Appendix G

re: Preliminary Grading Plan Review
East Urban Community (EUC) Mixed Use CDP - MSS
Mer Bleue Road - Ottawa

file: PG3130-MEMO.02 Rev.1

re: **Geotechnical Review - Proposed Services**
East Urban Community (EUC) Mixed Use CDP - MSS
Mer Bleue Road - Ottawa

EAST URBAN COMMUNITY MIXED USE CENTRE COMMUNITY DESIGN PLAN
 GRADING PLAN

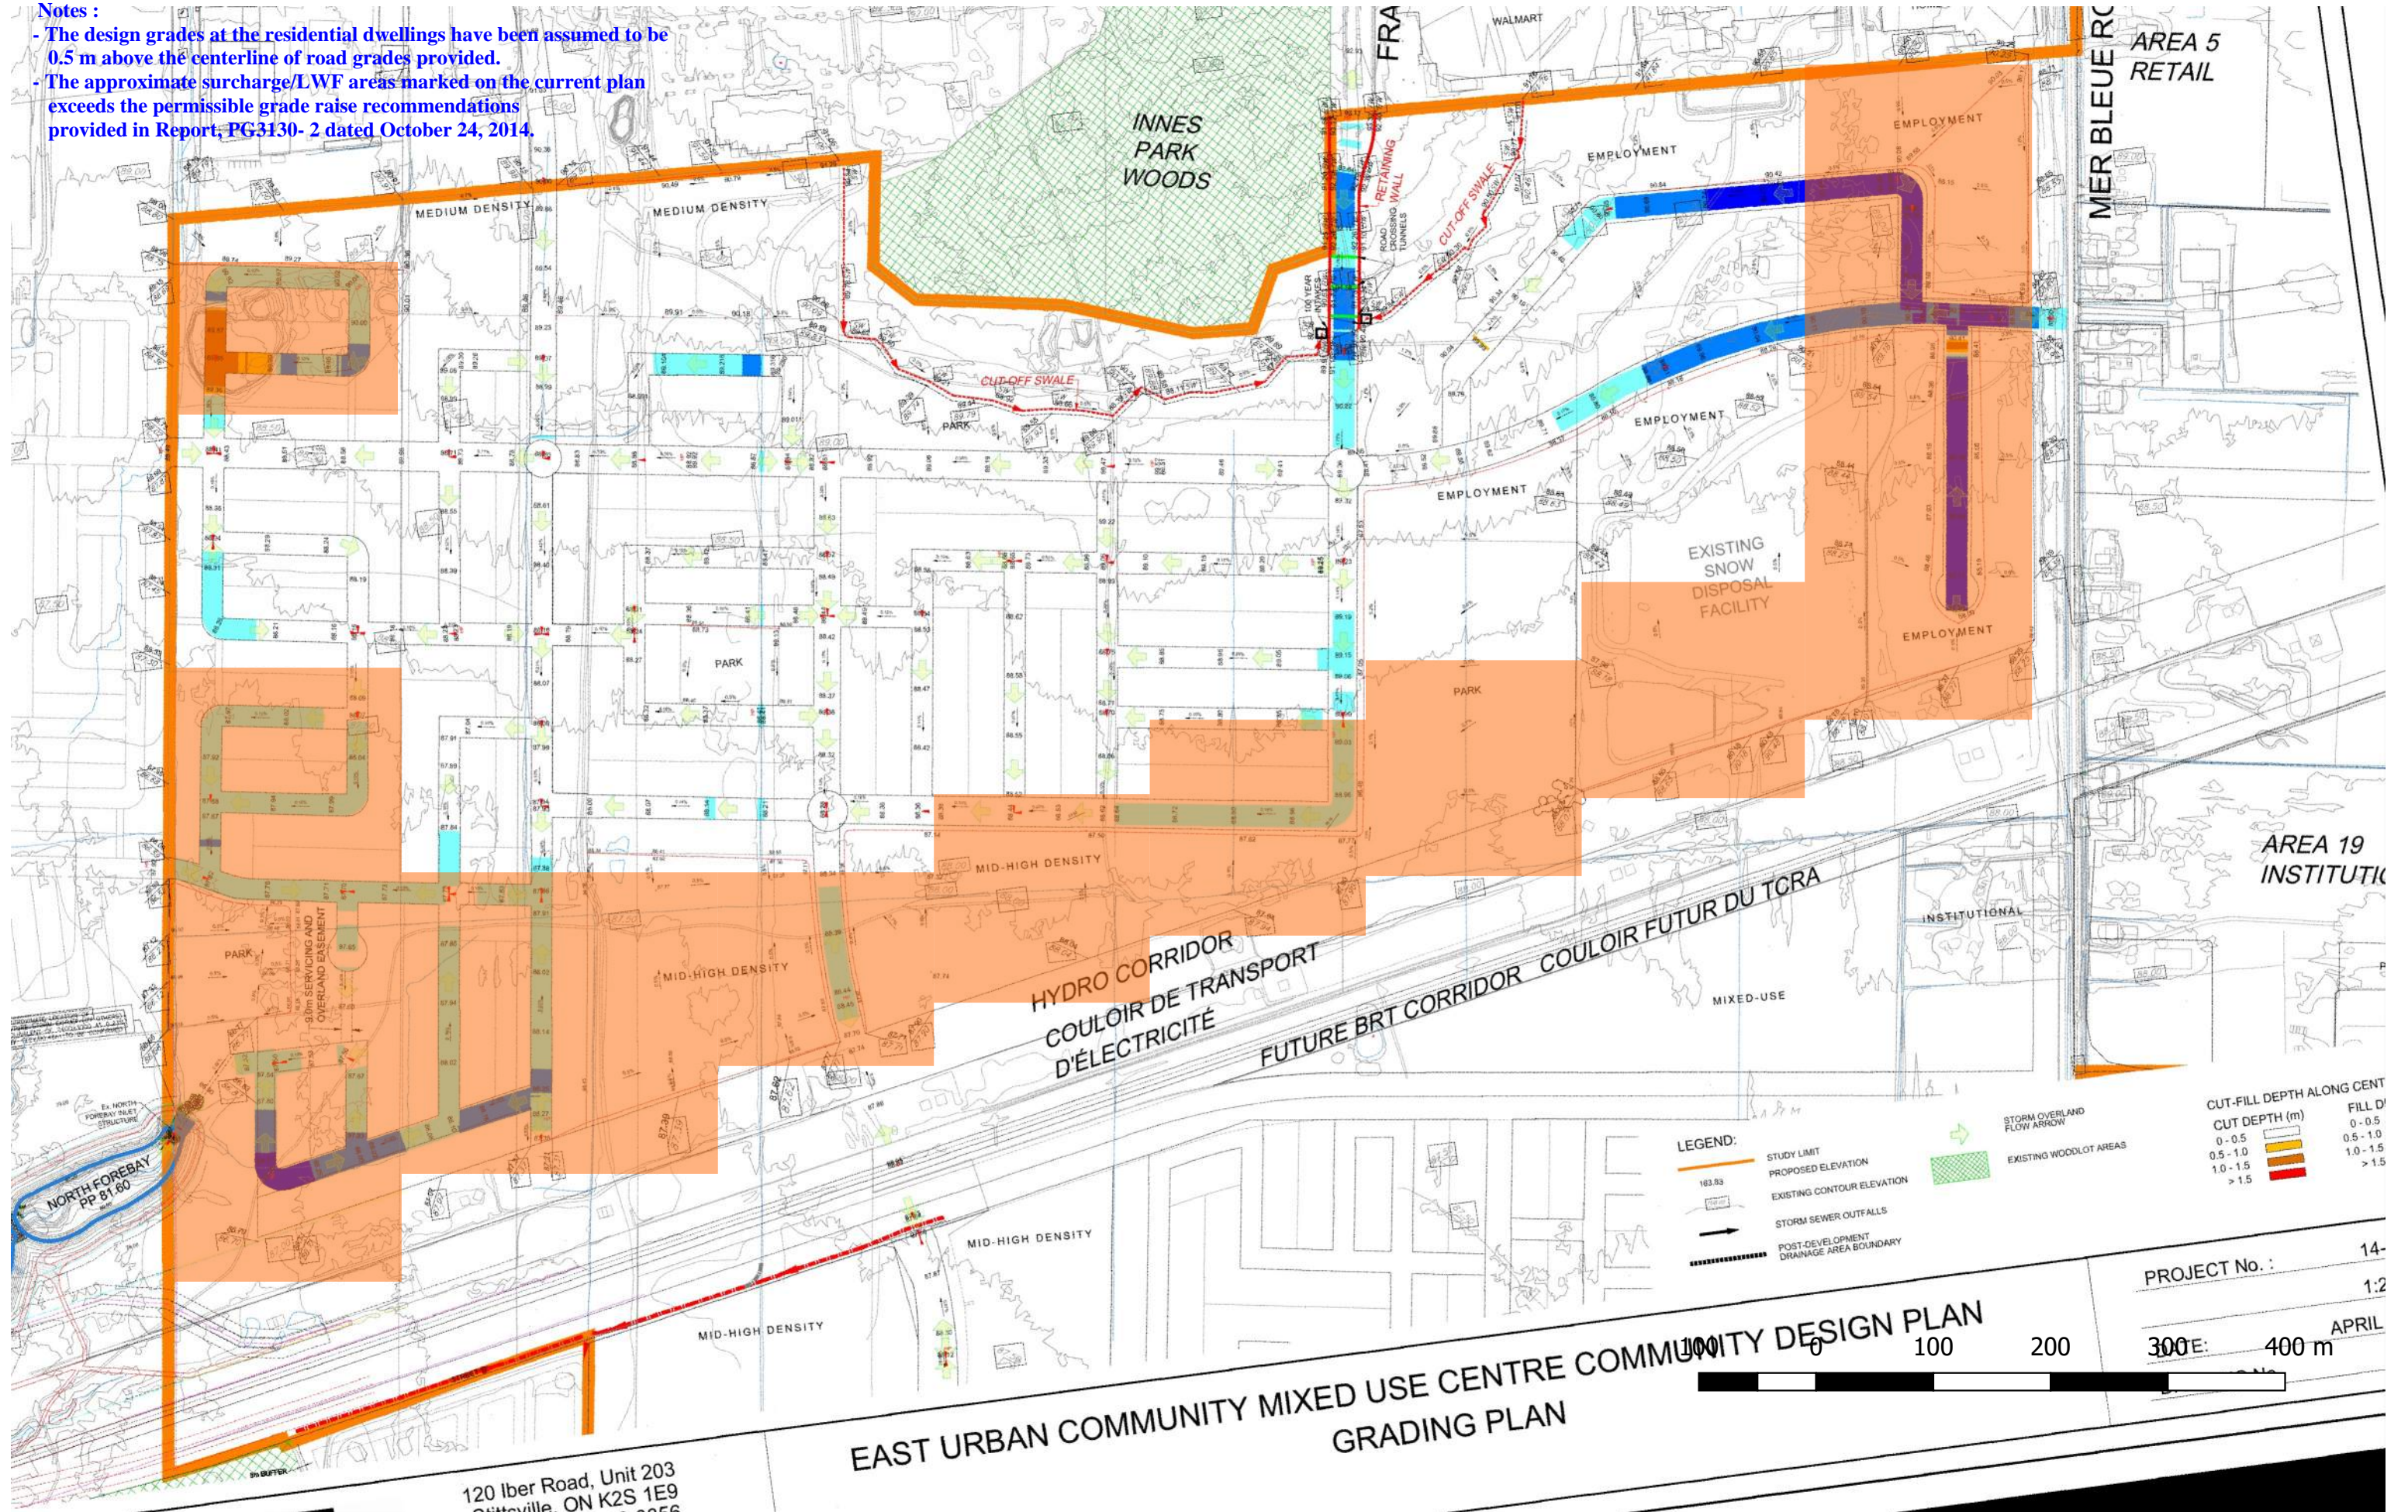
Approximate Surcharge/LWF Areas Based on Existing Subsoil Information

- The design grades at the residential dwellings have been assumed to be 0.5 m above the centerline of road grades provided.
- The approximate surcharge/LWF areas marked on the current plan exceeds the permissible grade raise recommendations provided in Report, PG3130- 2 dated October 24, 2014.

PG3130 - Preliminary LWF/Surcharge Areas For EUC - Paterson Recommendations

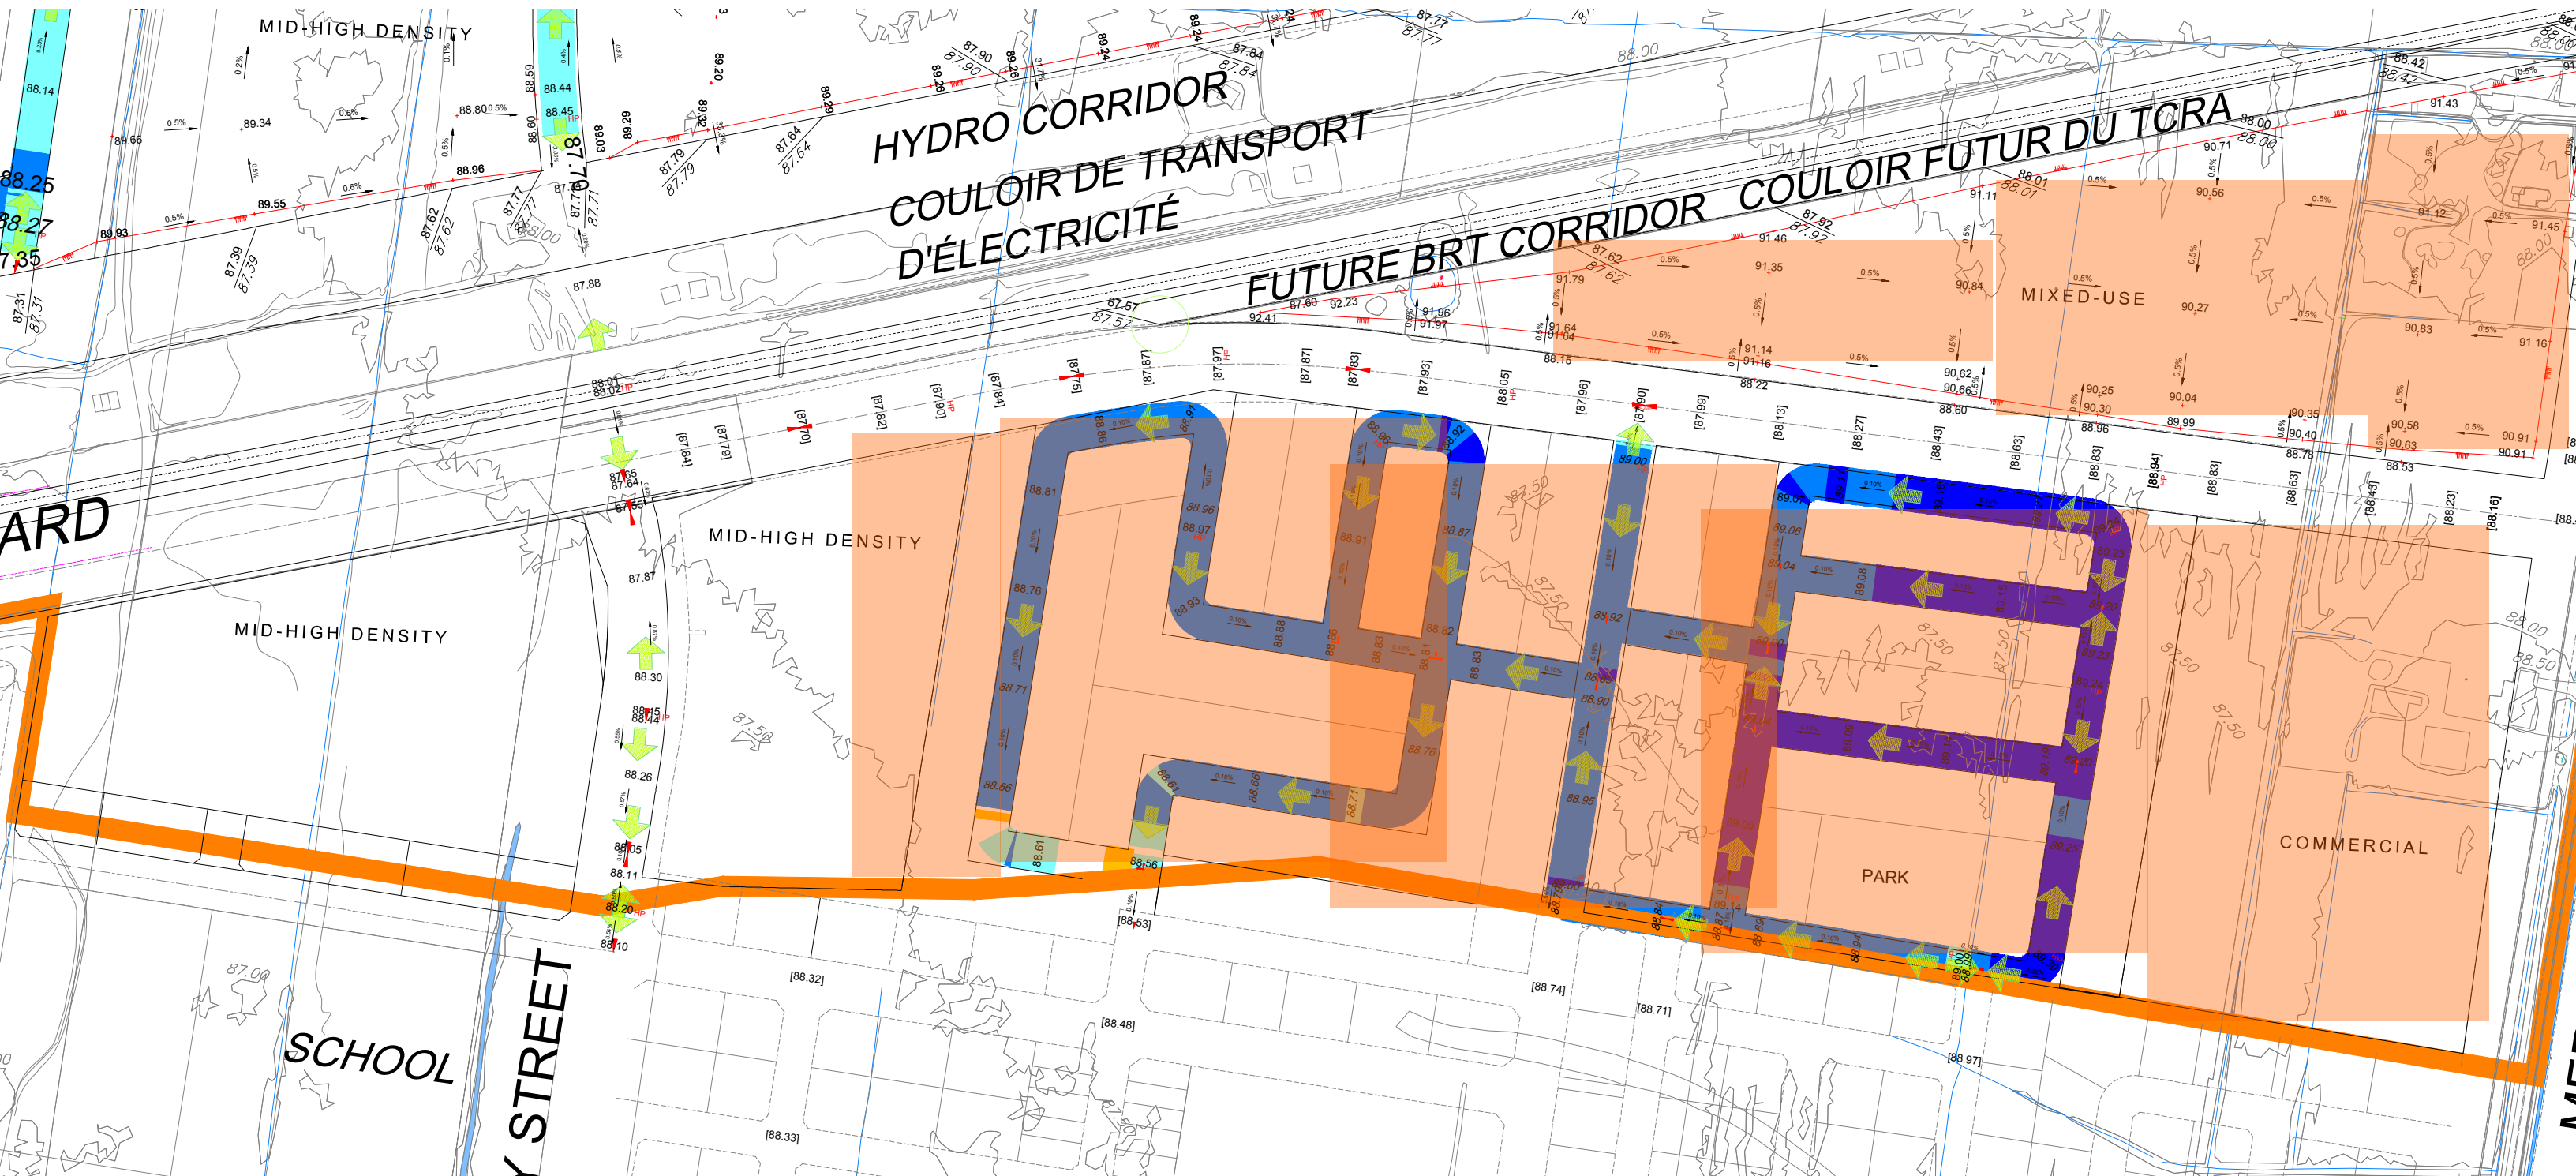
Reference should be made to the attached plan outlining the anticipated LWF/Surcharge areas using the presented grades. Also, a second plan is attached outlining the LWF/Surcharge areas assuming an additional 0.5 m above the currently proposed grades. It should be further noted that only the surcharge option is available for areas where roadways exceed our permissible grade raise recommendations.

- Notes:
- The design grades at the proposed buildings were assumed to be 0.5 m above the centerline of road grades provided.
 - The marked areas on the plan exceed the preliminary grade raise restrictions for the subject site.

PG3130 - Preliminary LWF/Surcharge Areas For EUC - Paterson Recommendations with Additional 0.5 m Above Proposed Grades

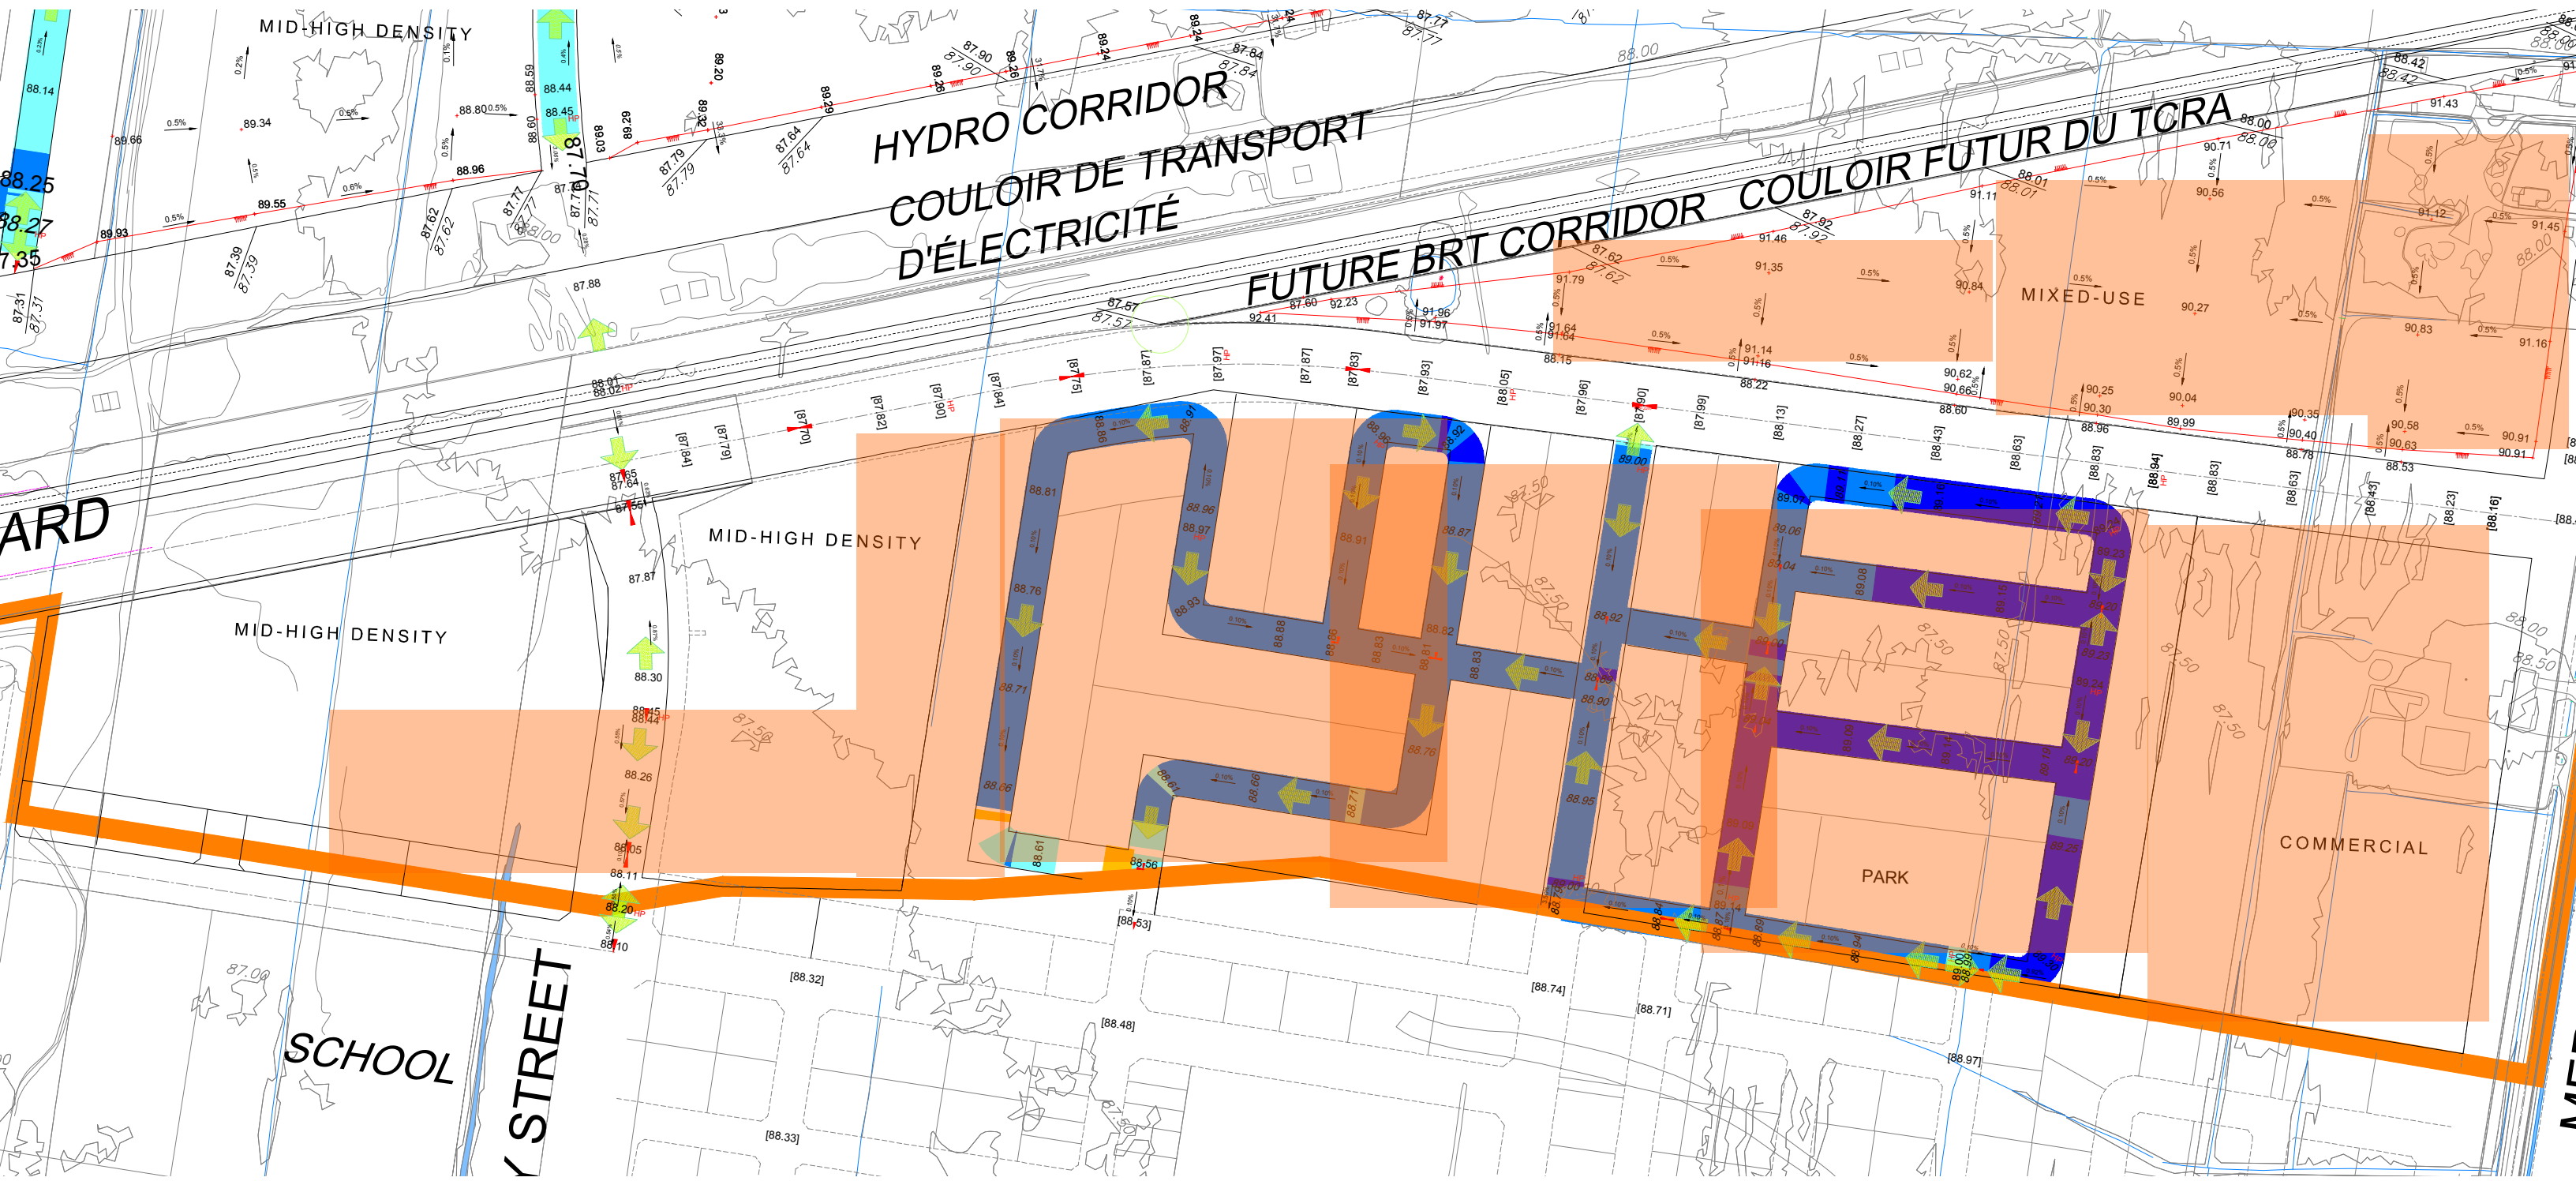
- Notes:**
- The design grades at the proposed buildings were assumed to be 0.5 m above the centerline of road grades provided.
 - The marked areas on the plan exceed the preliminary grade raise restrictions for the subject site.
